**Attachment 1 –
Revised Drainage Impact Assessment**

Drainage Impact Assessment

Report Reference: 240010.03

**Proposed Residential Development at
Various Lots in DD385, Tai Lam Chung, Tuen Mun
Response to Comments on Drainage Impact Assessment (DIA) Report**

60281828/STUDY/FIGURE 7

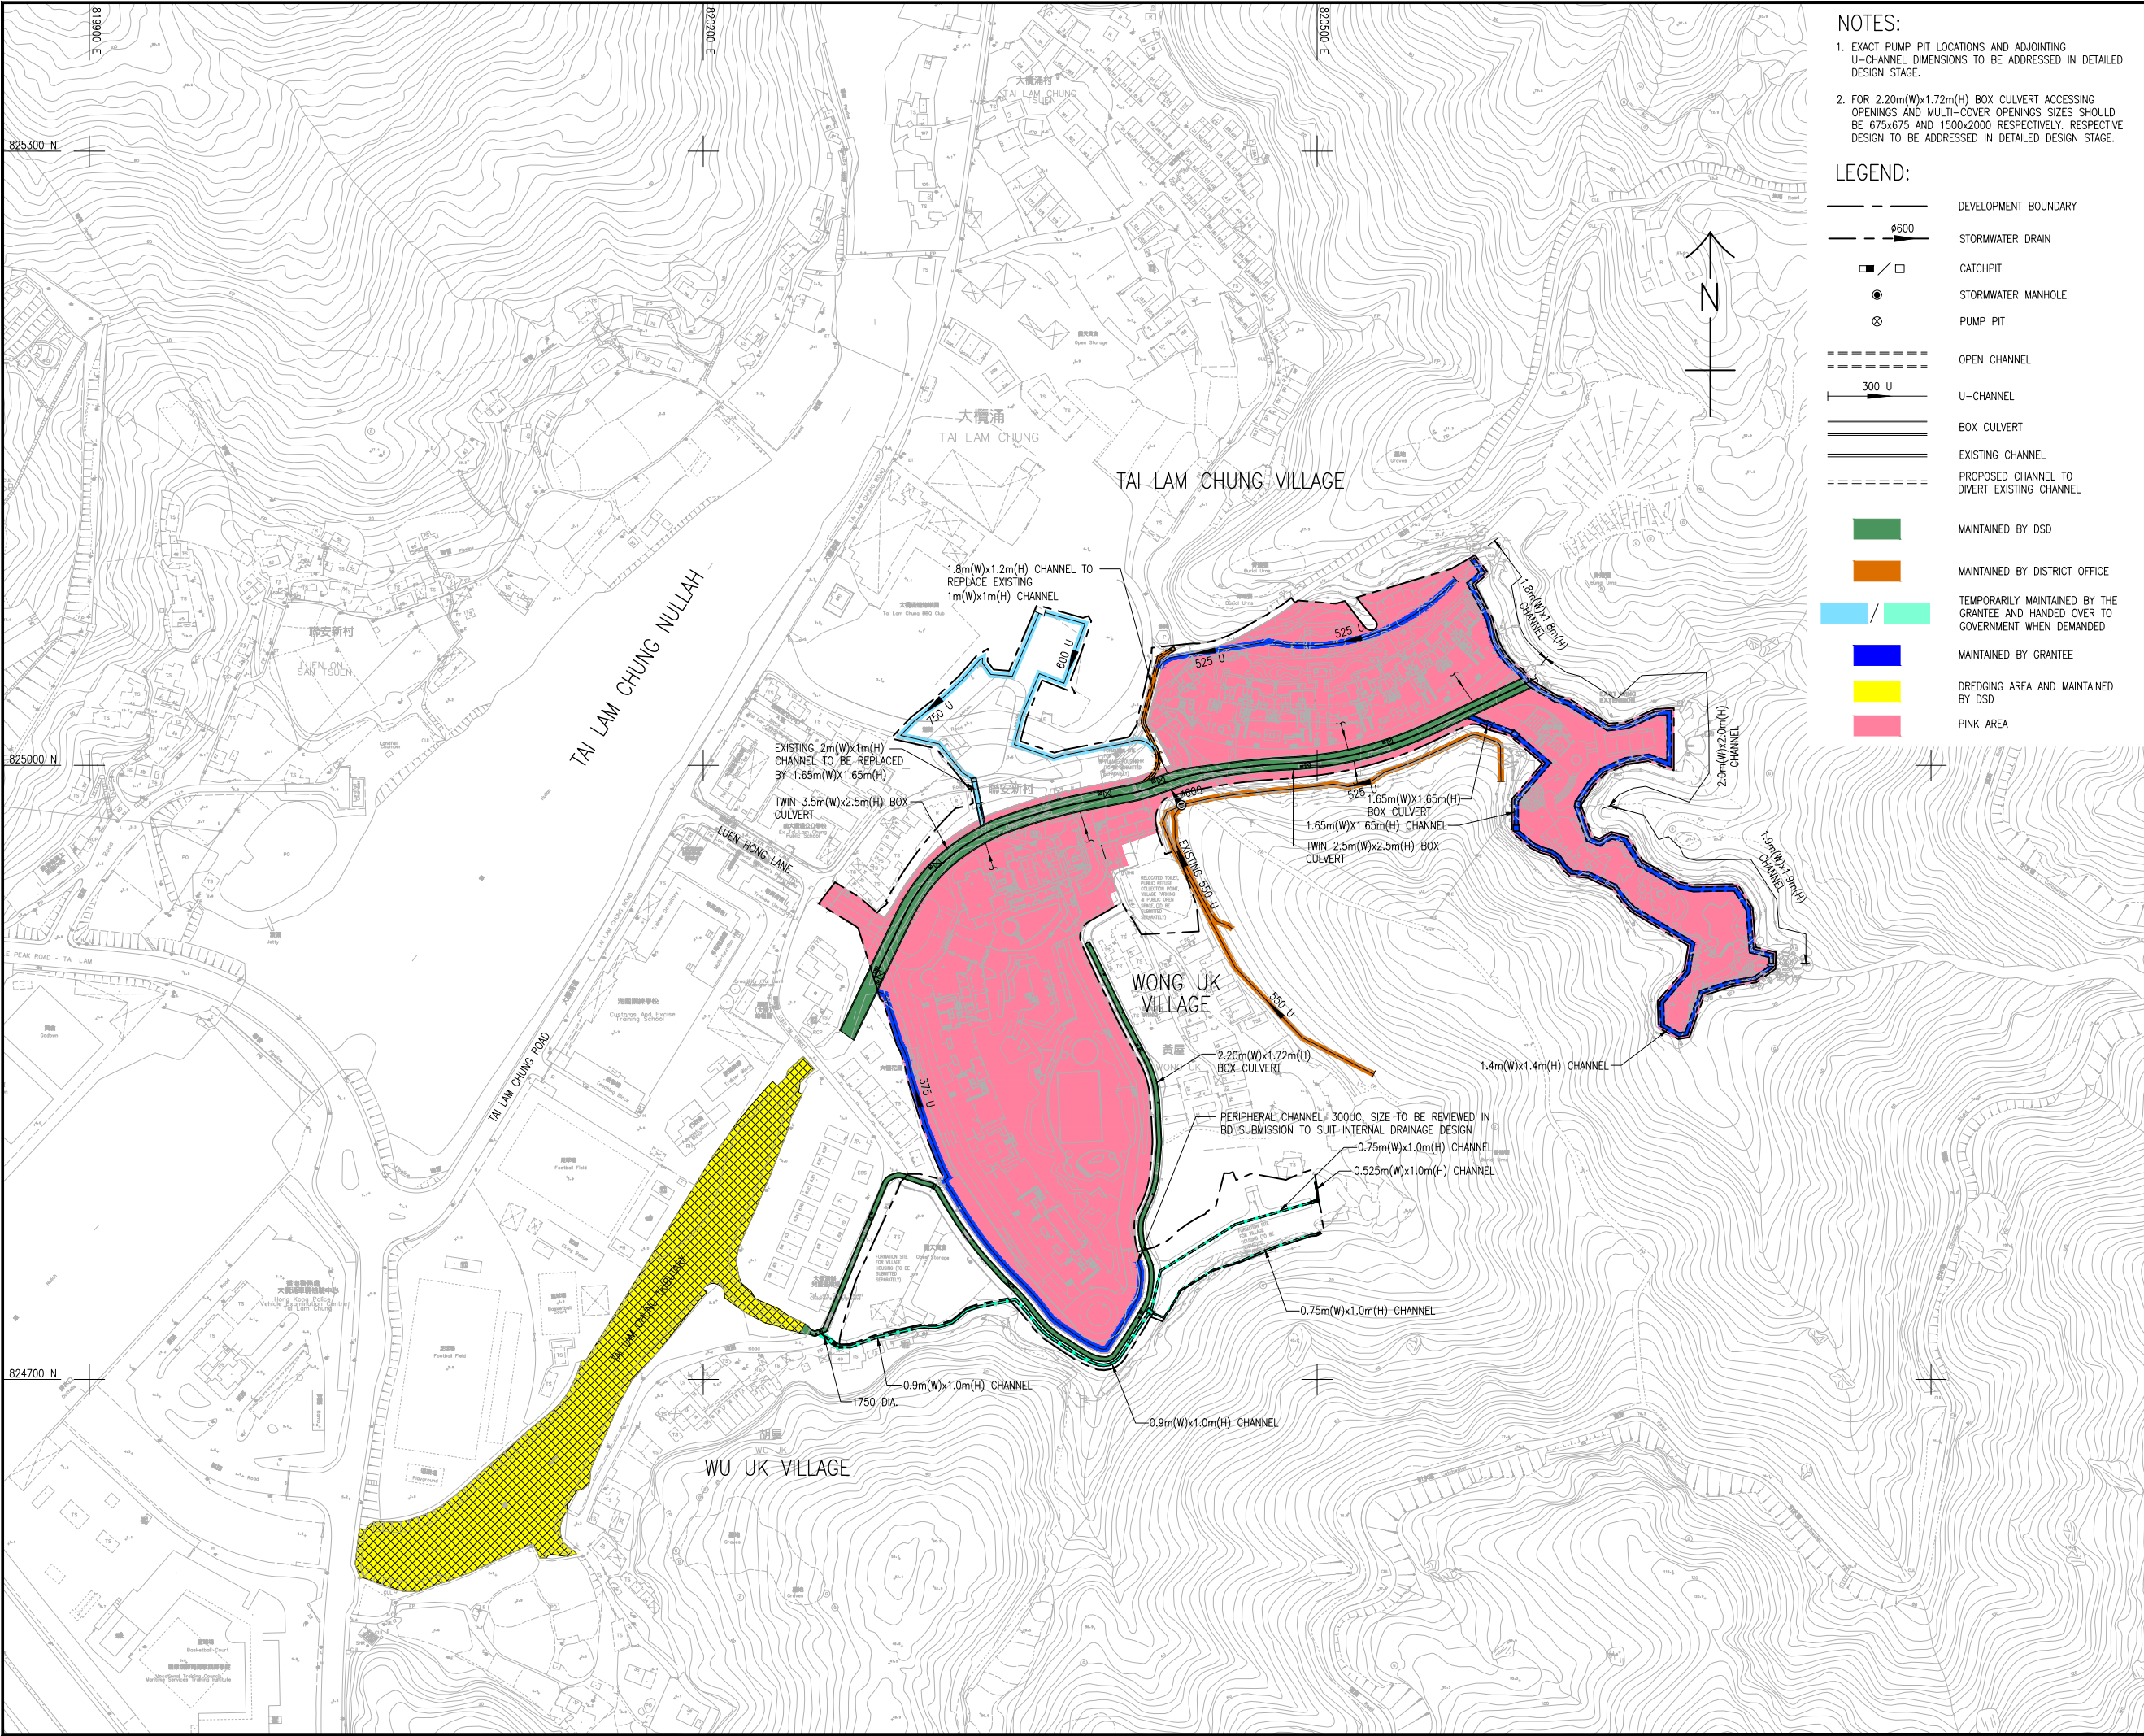
In response to the abovementioned replies, we are pleased to submit herewith the revised maintenance arrangement plan (Sheet Number: 60281828/STUDY/FIGURE 7) for your comment. The drainage works mentioned in the maintenance arrangement plan are referenced from the approved Drainage Impact Assessment dated 23 May 2023.

Figure 1: Existing Scenario at Wong Uk

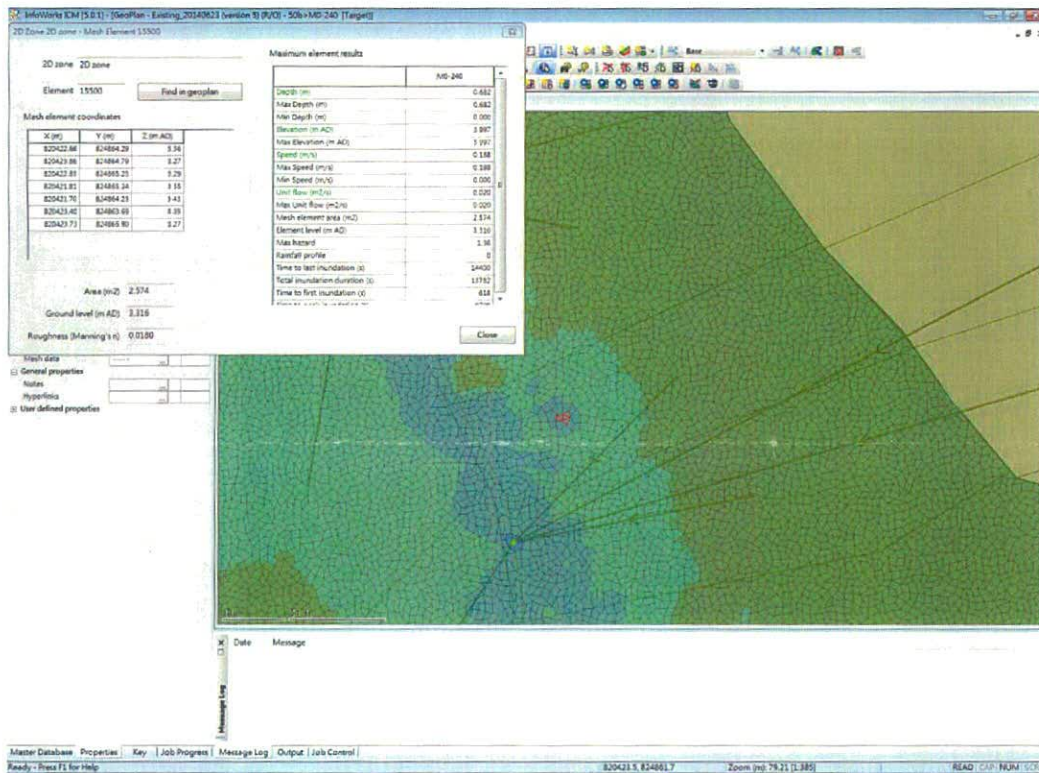
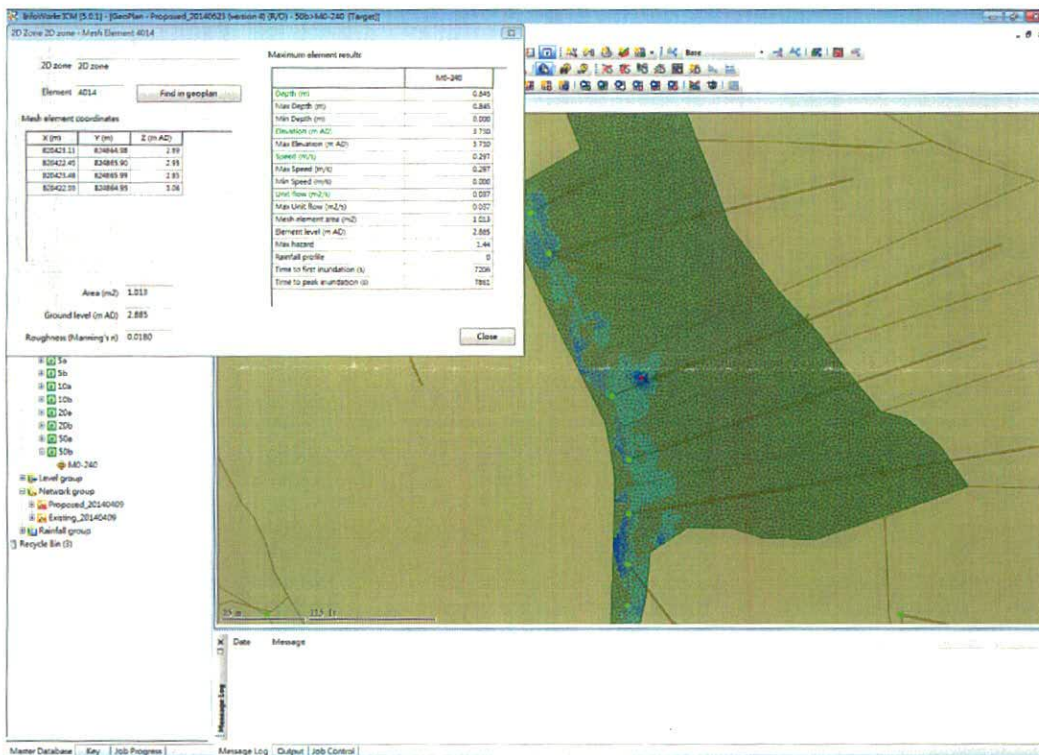
- (j) The flood depth at Wong Uk with coordinate (824864N, 820423E) in existing and proposed scenarios are 0.662m and 0.845m respectively. (see enclosed Appendix 2) There is 0.183m increase of flood depth. This will aggravate drainage conditions. Please revise the scheme.

The flood depth at Wong Uk with coordinate (824864N, 820423E) in existing and proposed scenarios are 0.662m and 0.845m respectively. There is 0.183m increase of flood depth. This will aggravate drainage conditions. Please revise the scheme.

After Development Scenario:

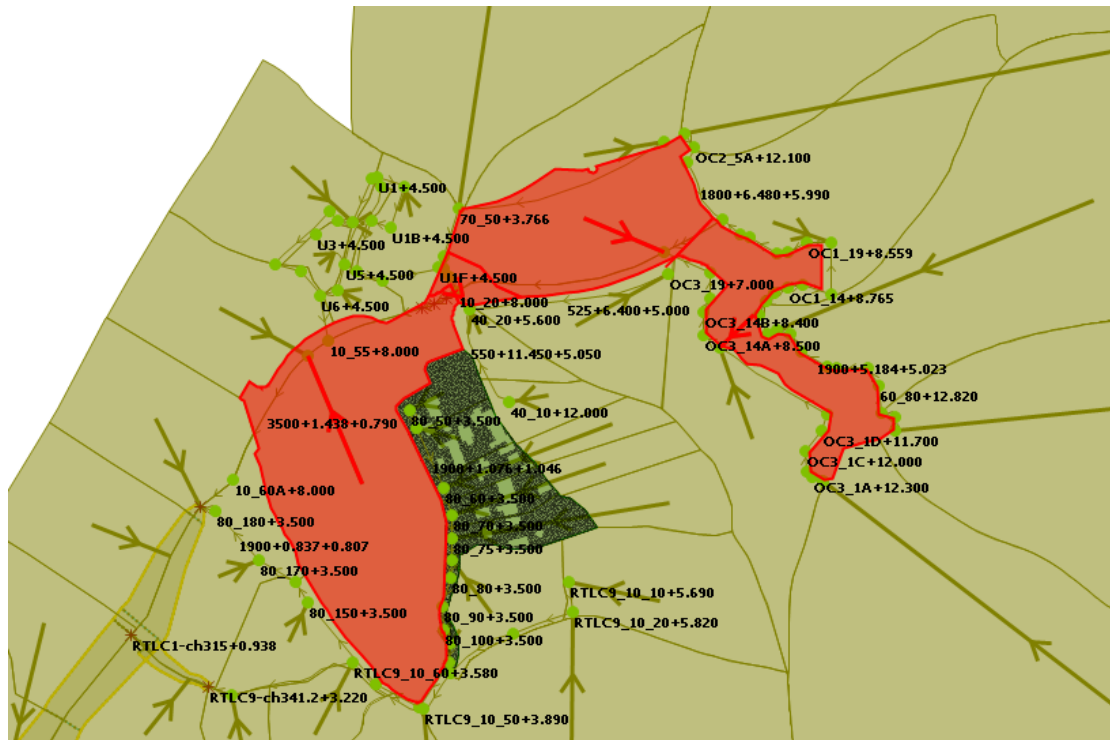
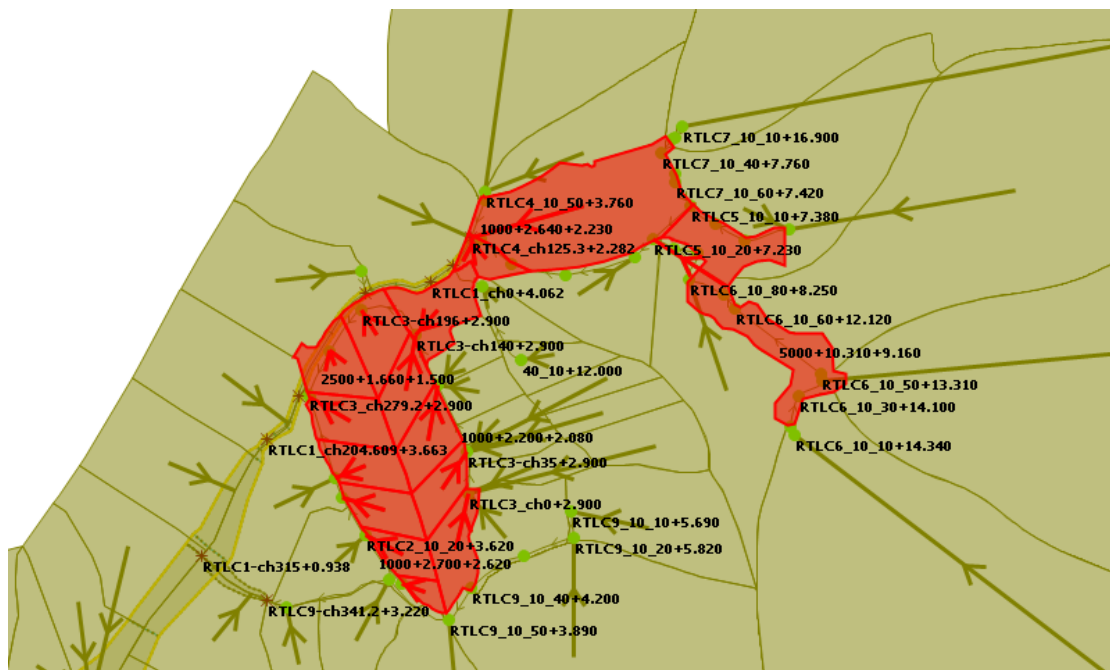
(4)		Please clarify the area and CN values in the Table 5.	Table 5 aims to explain the area CN value change due to the residential development. As shown in the Annex A with this responses to comments, in after development scenario, the catchments where residential development falls into have CN value of 87.5 based on 70% urban (CN95) and 30% greenery (CN70) assumption. As a comparison, in before development scenario, the area is storage, so a CN of 90 is assigned.

Residential Development Area = 4.604 ha. CN value for each sub-catchment is 87.5

Similar Area where residential development falls = 4.669 ha. CN value for each sub-catchment is 90

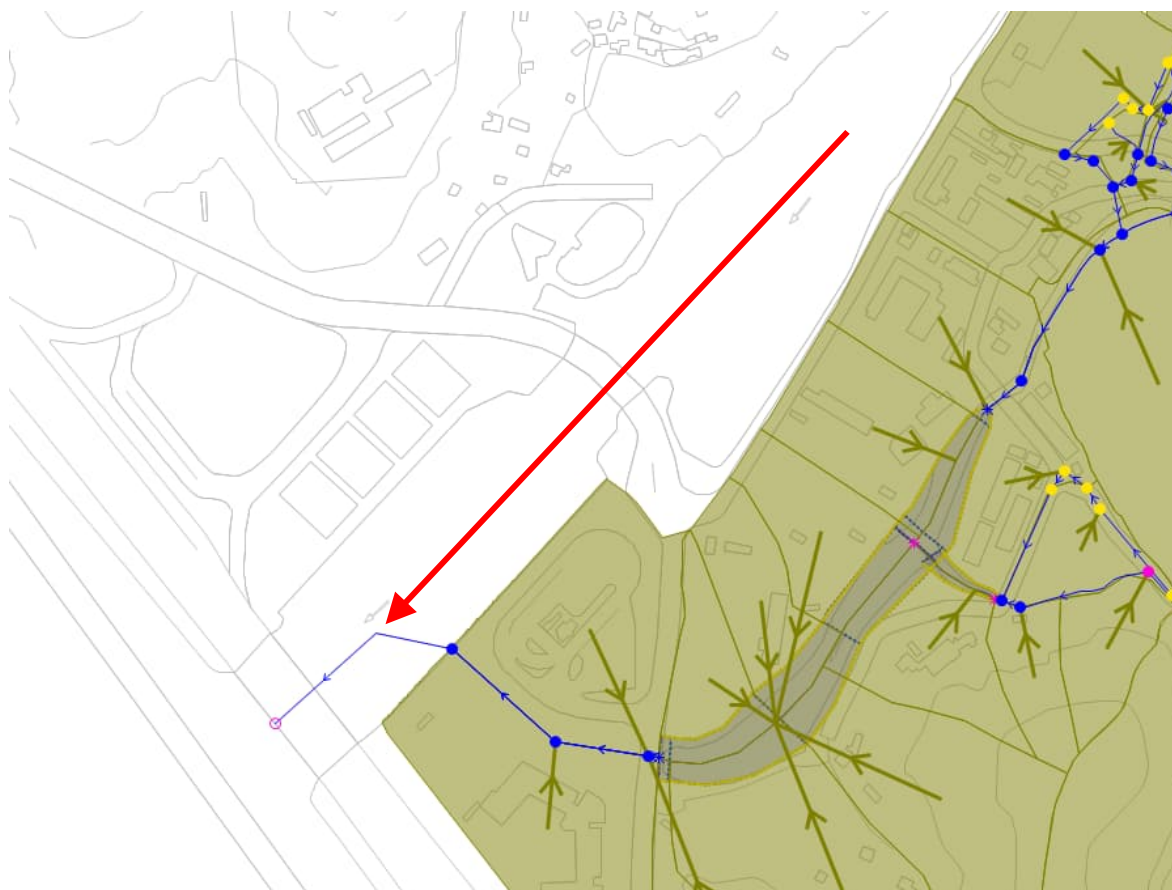
2. Upstream flow of the Tai Lam Chung was ignored. Please review.

3. Value of catchment B2 and U1 in Table 1 are duplicated. Please clarify.

(3)	Value of catchment B2 and U1 in Table 1 are duplicated. Please clarify	Table 1 is revised.
(4)	Drainage network is inconsistent with our drainage record and the drainage arrangement. Please review.	The hydraulic model is revised accordingly.
